# CITY OF POMONA

**SUBJECT:** APPEAL OF MINOR CERTIFICATE OF APPROPRIATENESS (MINCOA 014419-2020)

Appeal of Minor Certificate of Appropriateness (MINCOA 014419-2020), which denied the installation a new walkway, low-lying wall, fountain with a concrete pad, and approved modifications to landscaping within the front yard setback on a contributing single-family residential dwelling within the R-1-6,000 (Single Family Residential) zone at 219 E. Garfield Avenue in the Lincoln Park Historic District.

**Figure 1. Site Plan**

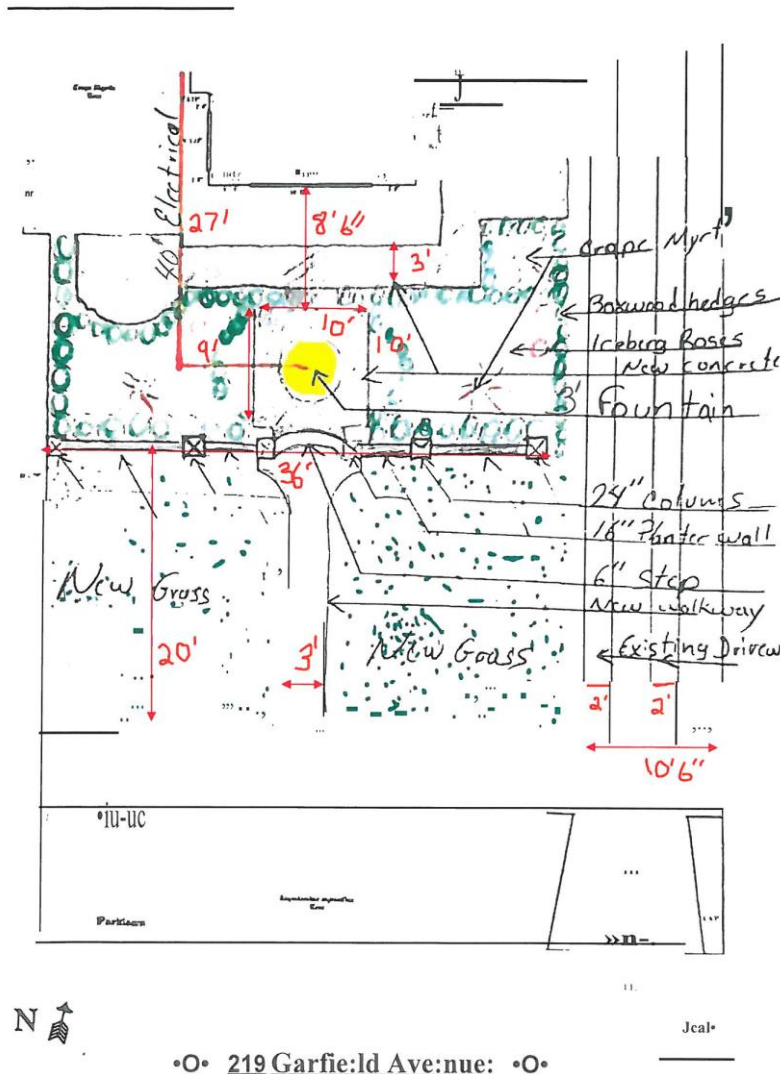
On Oct. 21, 2020, Planning staff partially approved MINCOA 014419-2020 for landscaping modifications including the planting of two Crape Myrtle trees and boxwood hedges within the front yard setback as indicated in the submitted plans (figure 1). The approved landscape changes are subject to review and approval from the City Arborist to ensure compatibility with the recommended tree palette. The City Arborist also reviews the location of the proposed trees and their relationship with the surrounding neighborhood.

On Oct. 21, 2020, Planning staff partially denied MINCOA 014419-2020 to install a new walkway, low-lying wall, and fountain with concrete pad. Section .5809-13 – Historic Preservation of the Pomona Zoning Ordinance (PZO) requires a Minor Certificate of Appropriateness for the installation of new walkways, walls, and additional elements that are not historically a part of the site. Both the PZO and Guidelines for Alterations to Pomona’s Historic Properties, 1999 (“Guidelines”), do not recommend installing elements that have a potential to negatively affect the “historic character” of the neighborhood. Specifically, the Fencing and Wall Design Standards for Properties Located in Designated Historic Districts state that “If fencing or retaining walls did not exist historically in the front yard setbacks, new fencing and walls in these locations shall not be installed except in matters of public safety” (Section 503-I.11(d) of the PZO).”

The Guidelines state the following: “The acceptability of a new fence or wall installation will depend on the existence of fences and walls in the immediate neighborhood. Whenever possible, avoid installing a new front yard fence or wall in neighborhoods with open front yards;” “In historic districts, front and side yard landscaping visible from the street should be compatible with the theme of the surrounding neighborhood,” “Avoid covering large areas that were historically grass with groundcovers, pavers, concrete, rock, wood whips, or other unhistorical materials” and “Avoid the addition of modern or historically inappropriate structures or accessories to front yard landscapes.” Based on the guidance outlined in the Guidelines, staff researched the surrounding neighborhood (specifically, the residential block between Gibbs Street and Bradford Street) within the Lincoln Park Historic District and found that it is characterized by open front yards without walls and the few existing walkways in the immediate neighborhood lead directly to the front entrances of homes. Additionally, staff’s research found that three (3) contributing properties to the Lincoln Park Historic District along the residential block surveyed were found to have historically inaccurate and unpermitted walkways (230 Garfield Ave., 263 Garfield Ave., & 286 Garfield Ave).
